**MODIFICATION –  
SKIMMER INSTALL FOR  
FACET & CANADIAN  
BUILT UNITS**

ENVIRONMENTAL SERVICES, INC.	DATE	BY	CHKD BY
PACIFIC GULF MARINE	05/06/09	PRELIMINARY	REVISION
MSD SKIMMER RETROFIT	05	033	001
GENERAL ARRANGEMENT

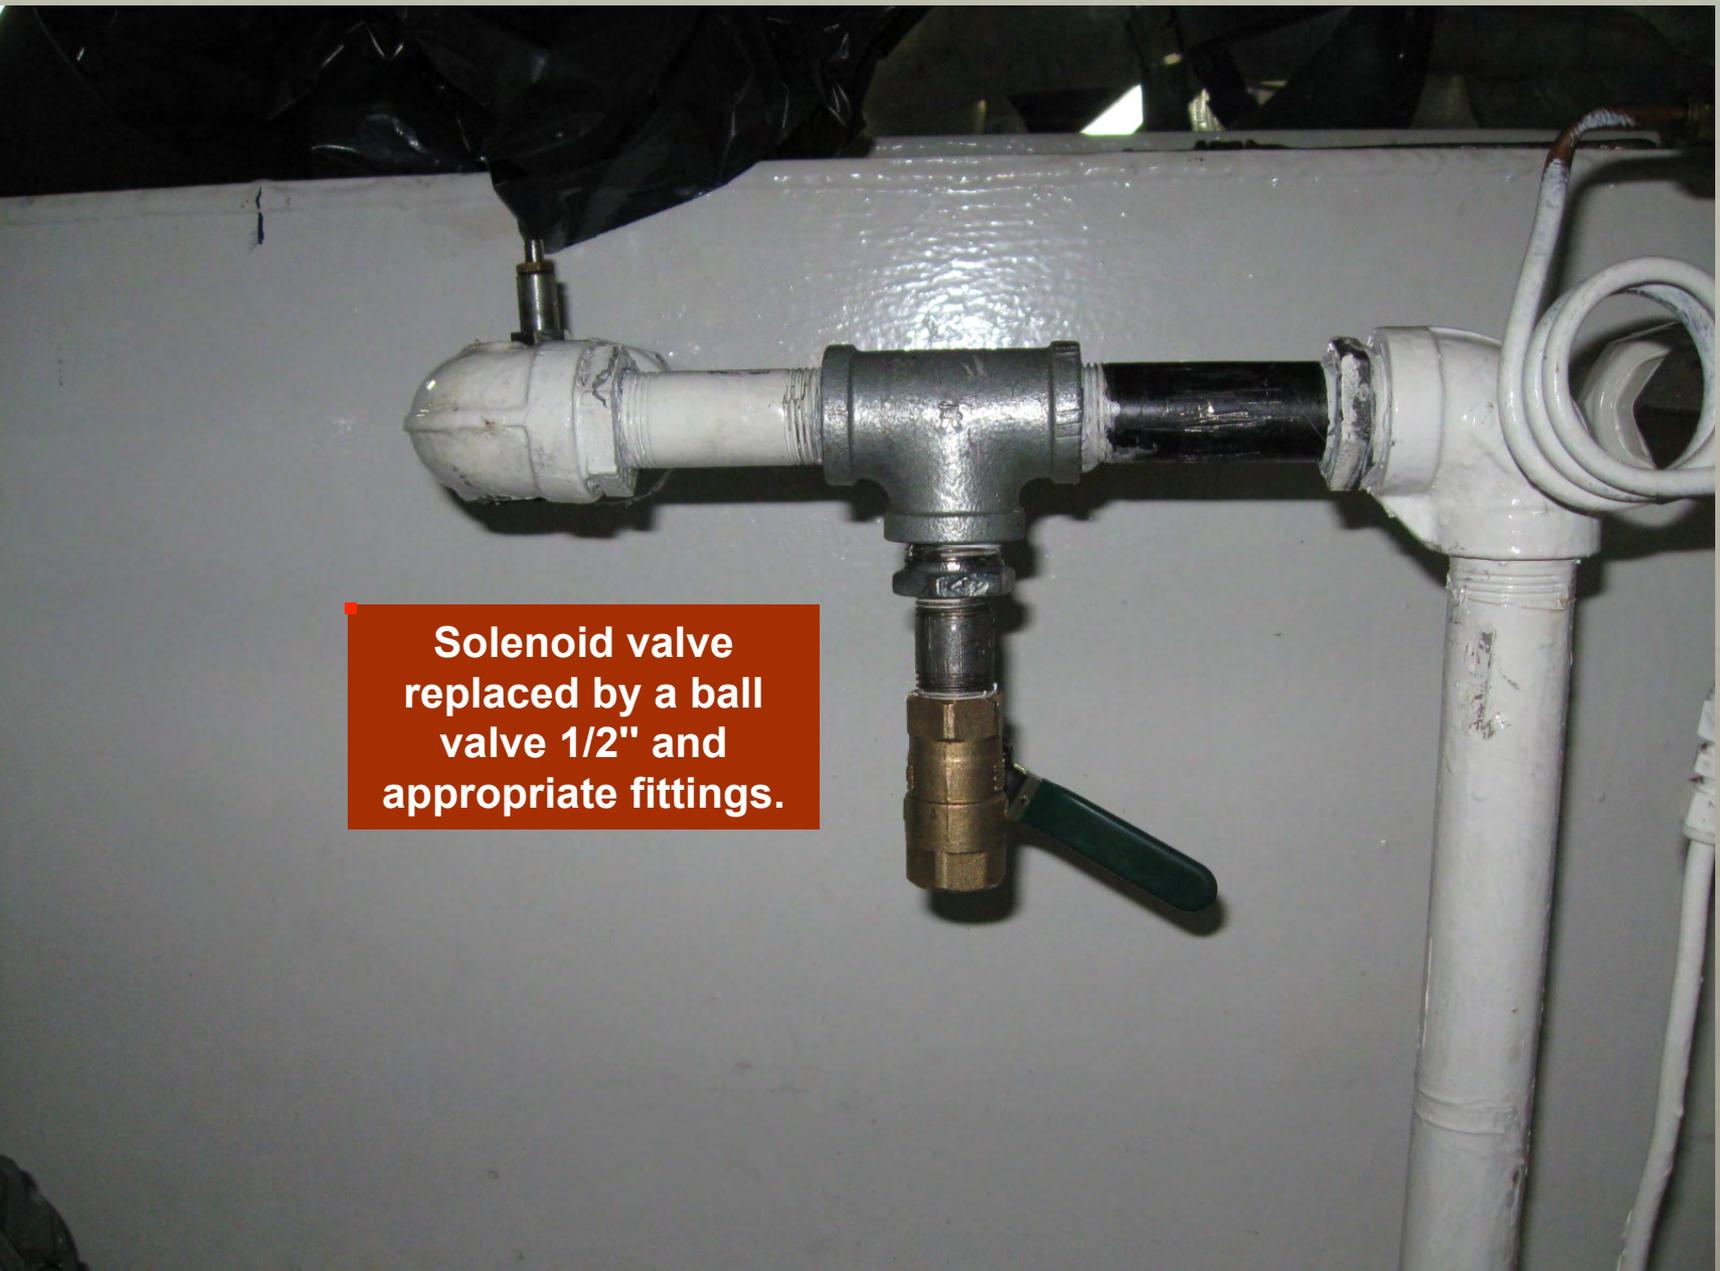
**Center of the lid  
(Important).**

**Solenoid valve  
replaced by a ball  
valve 1/2" and  
appropriate fittings.**

**Bulkhead installed  
on the lid.**

Drilled hole for the bulkhead of sludge return to the balance pipe from the second to the first course.

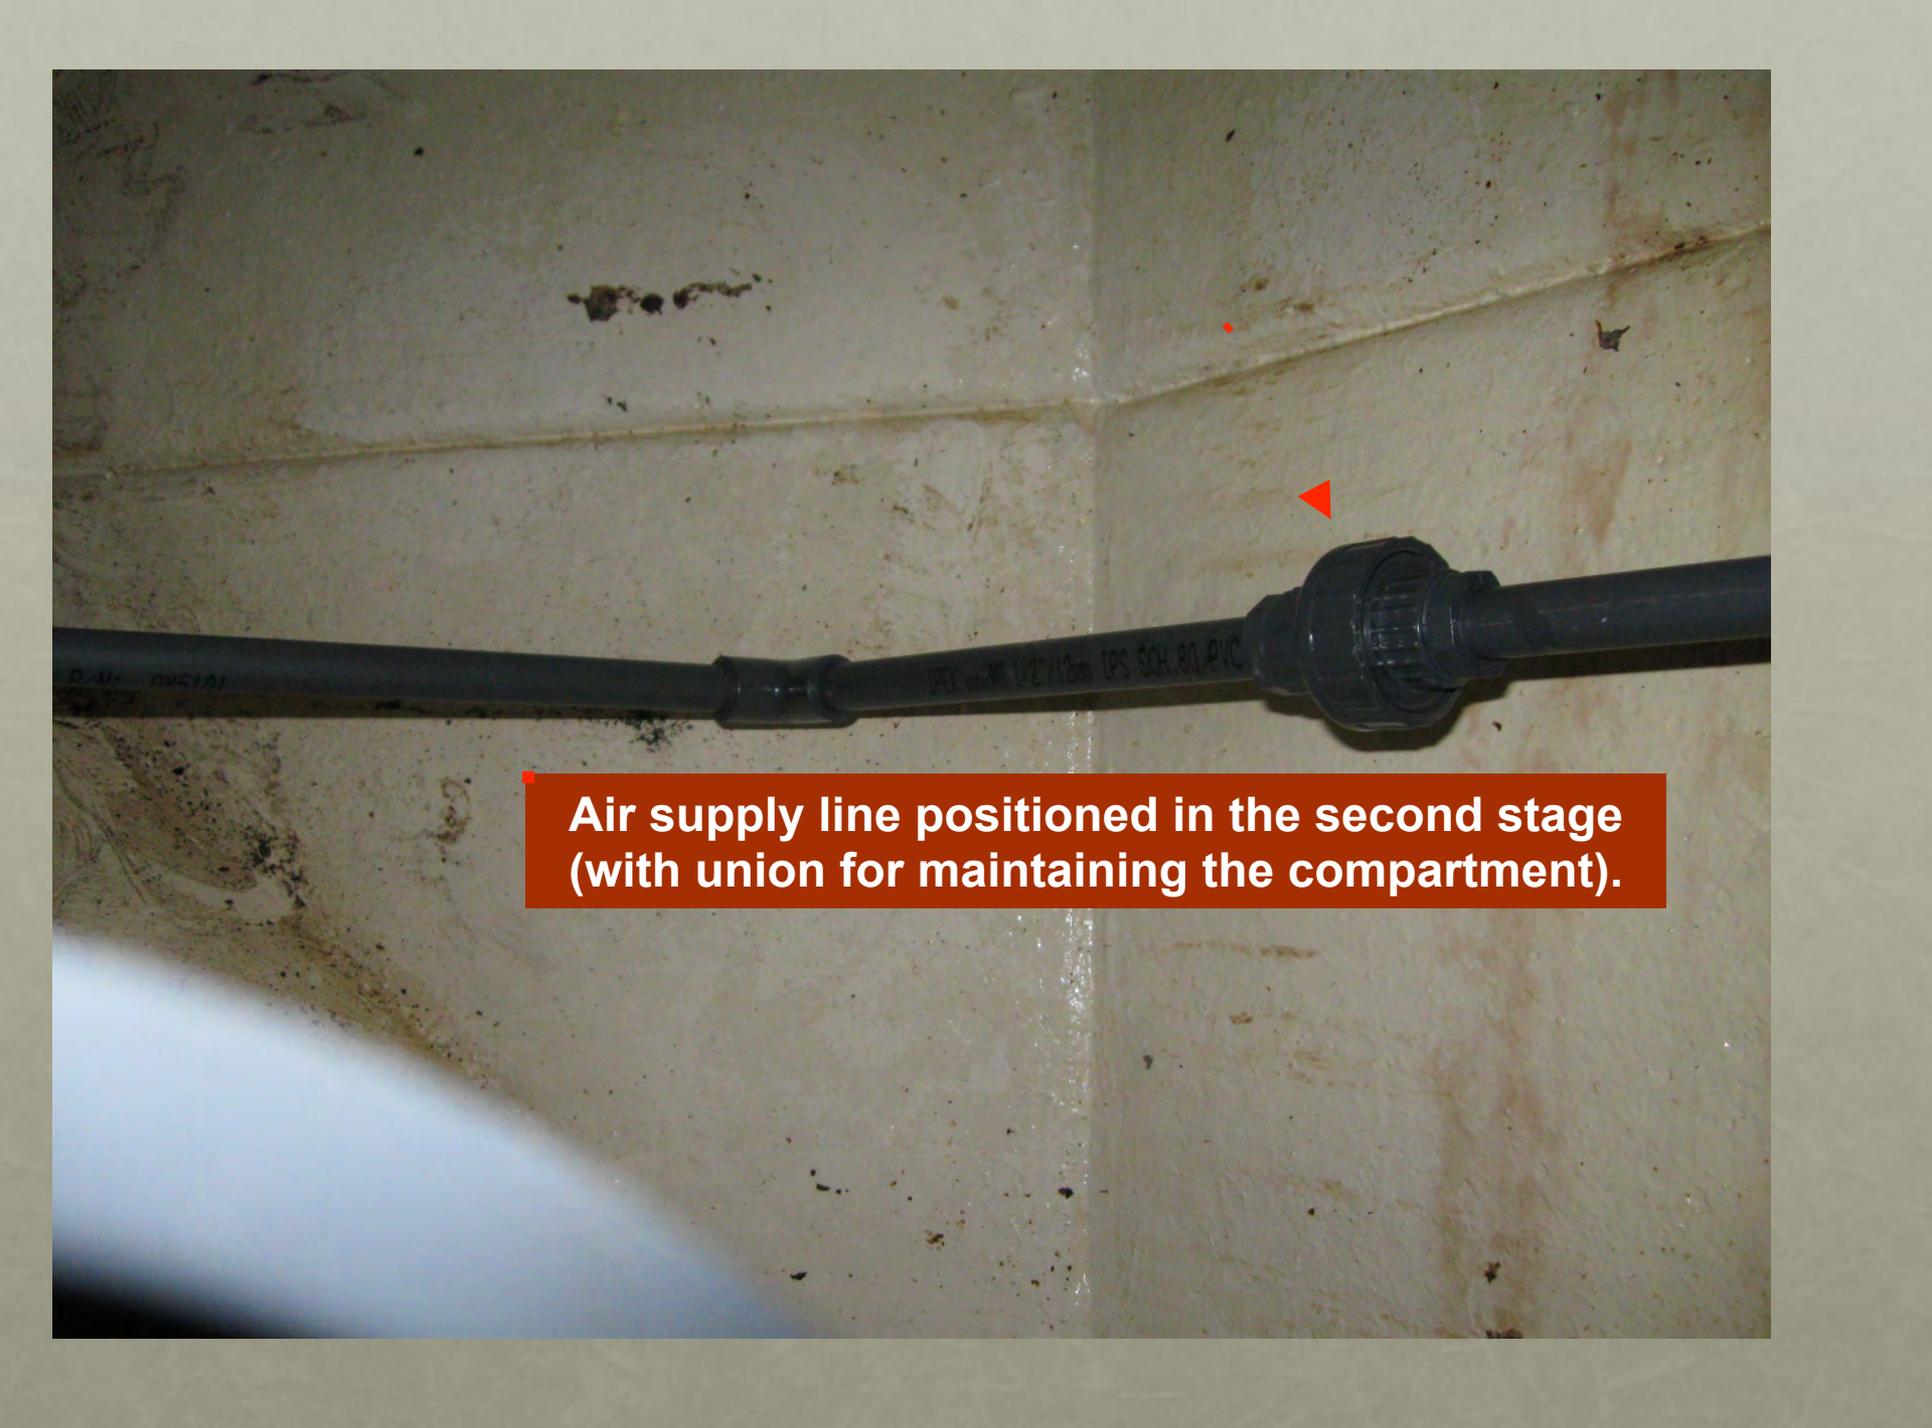
Positioned in the second stage for the return of sludge (with removable ring for the maintenance of the compartment) with the new air line attached and a new medium for the tip). The pipe should not touch the wall (bottom) of the funnel, it should be about 1/2".

The bulkhead splices must be installed so that they can tighten if necessary, during the operation.

**New removable  
pipe support, for  
easy  
maintenance.**

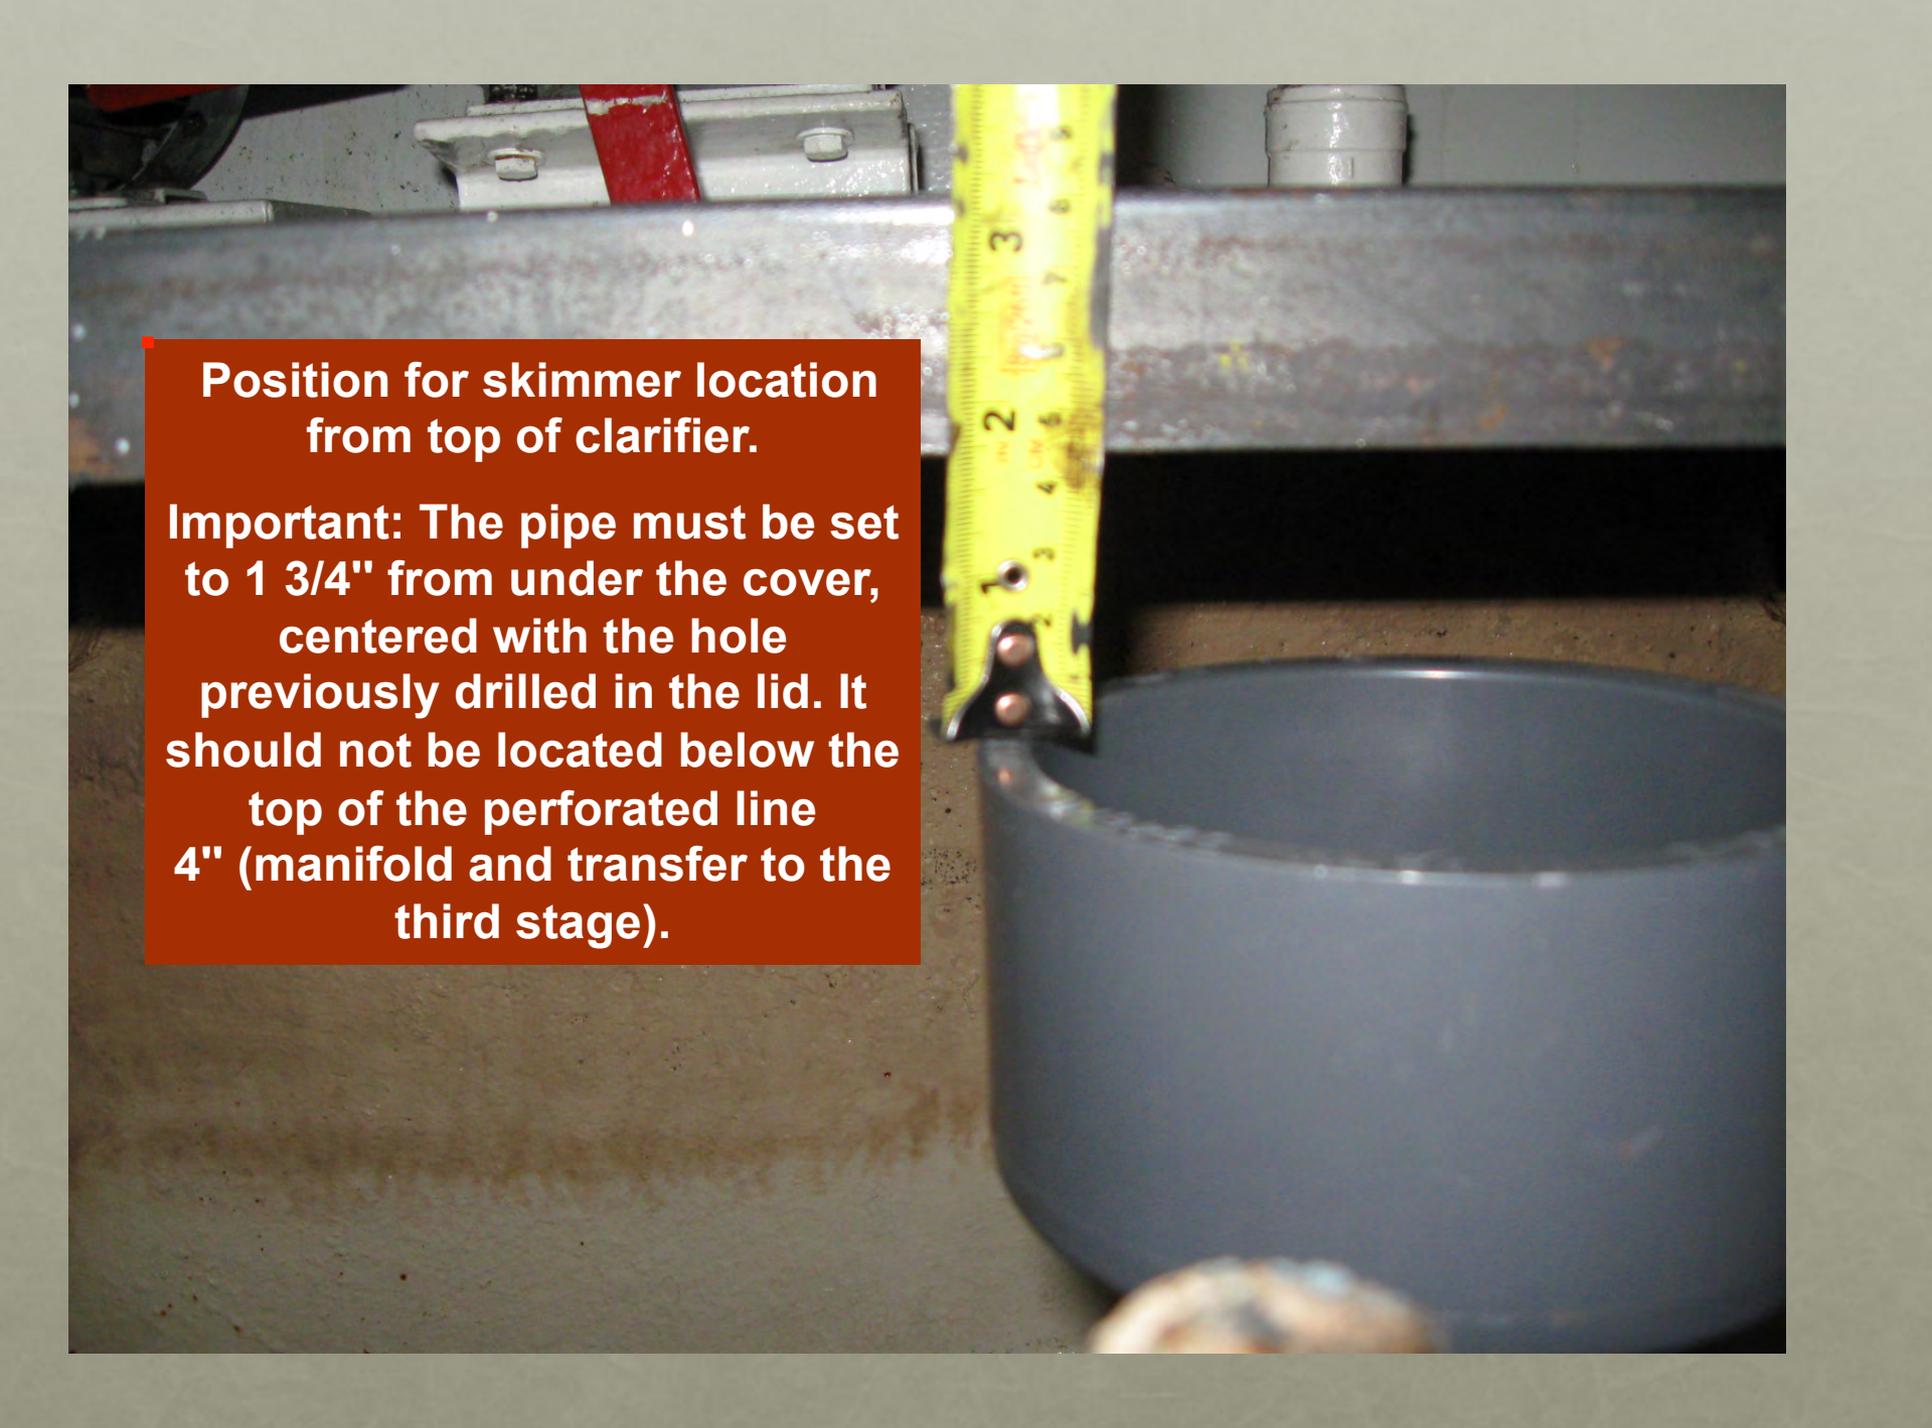
**Air supply line positioned in the second stage  
(with union for maintaining the compartment).**

**Position for skimmer location  
from top of clarifier.**

■ **Aeration Tank View**

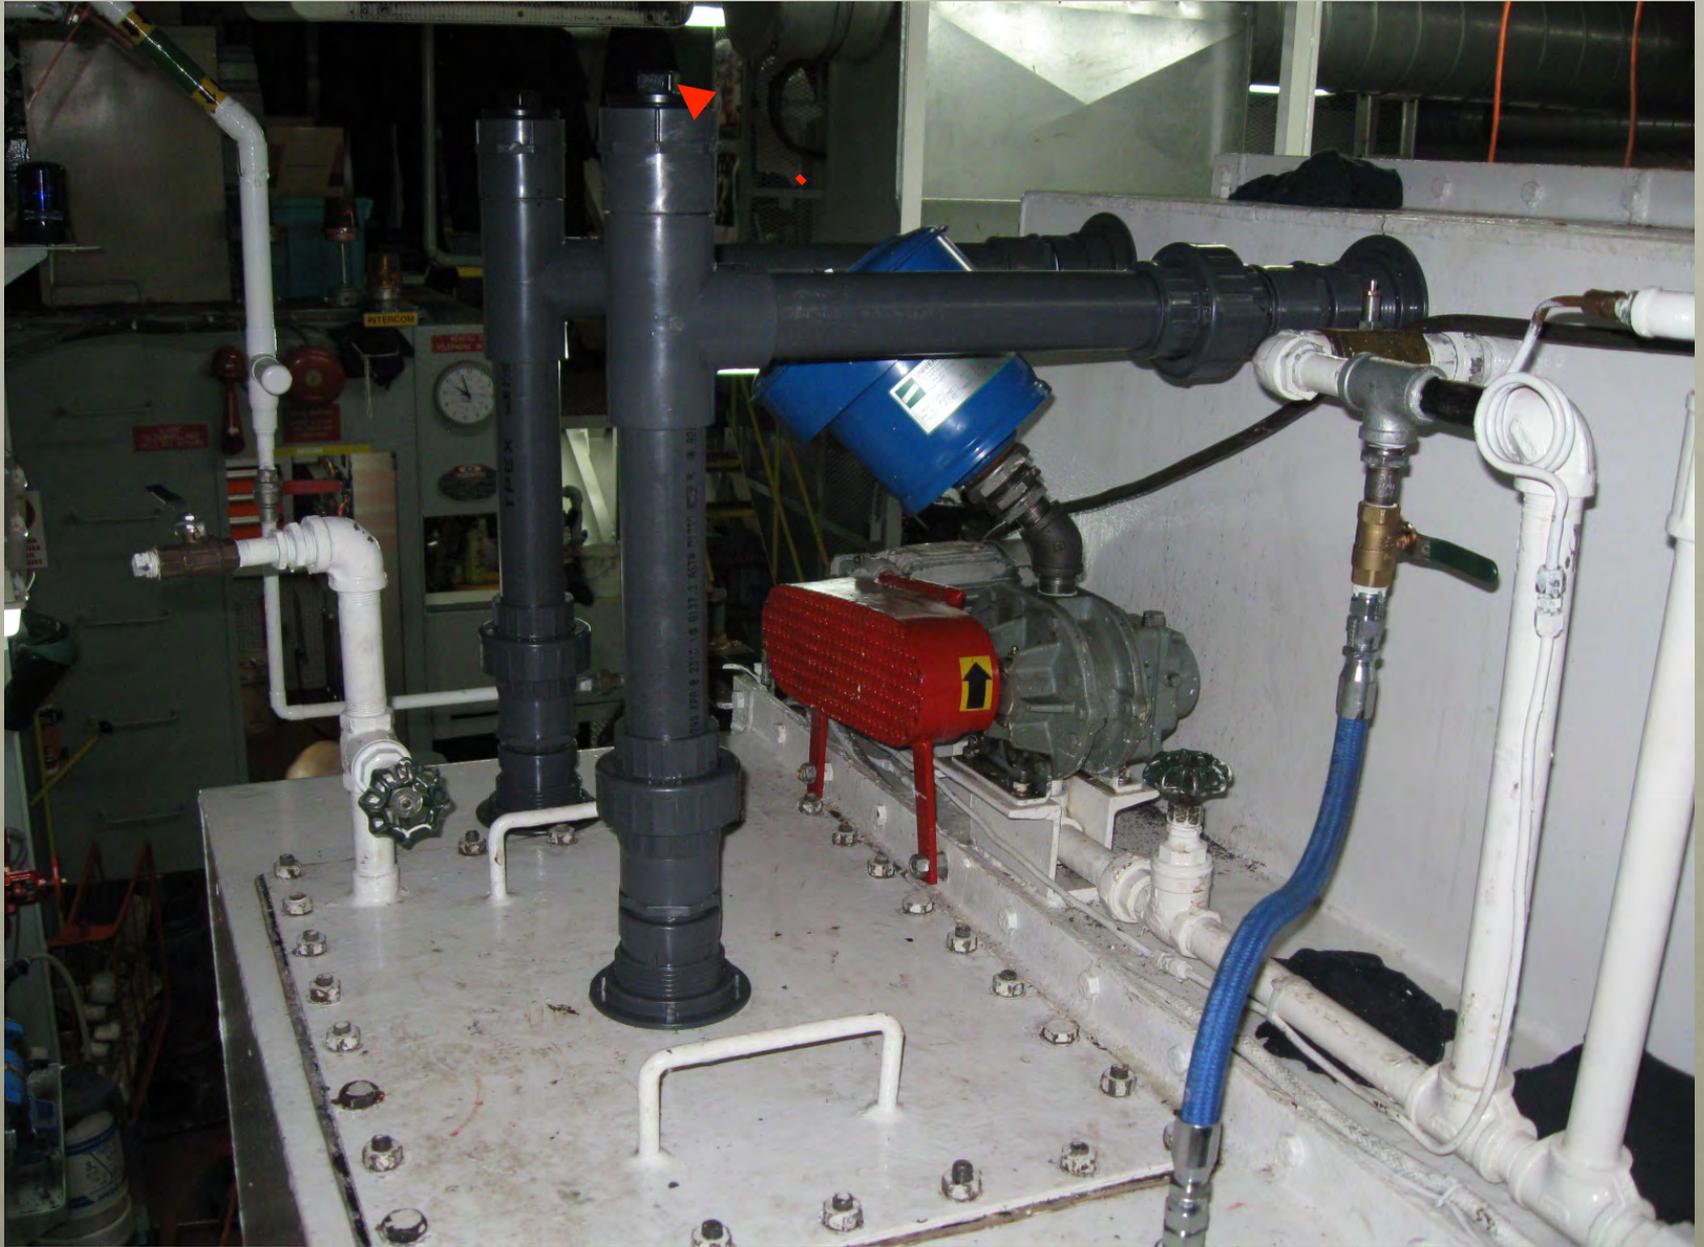
**Important: The pipe must be set  
to 1 3/4" from under the cover,  
centered with the hole  
previously drilled in the lid. It  
should not be located below the  
top of the perforated line  
4" (manifold and transfer to the  
third stage).**
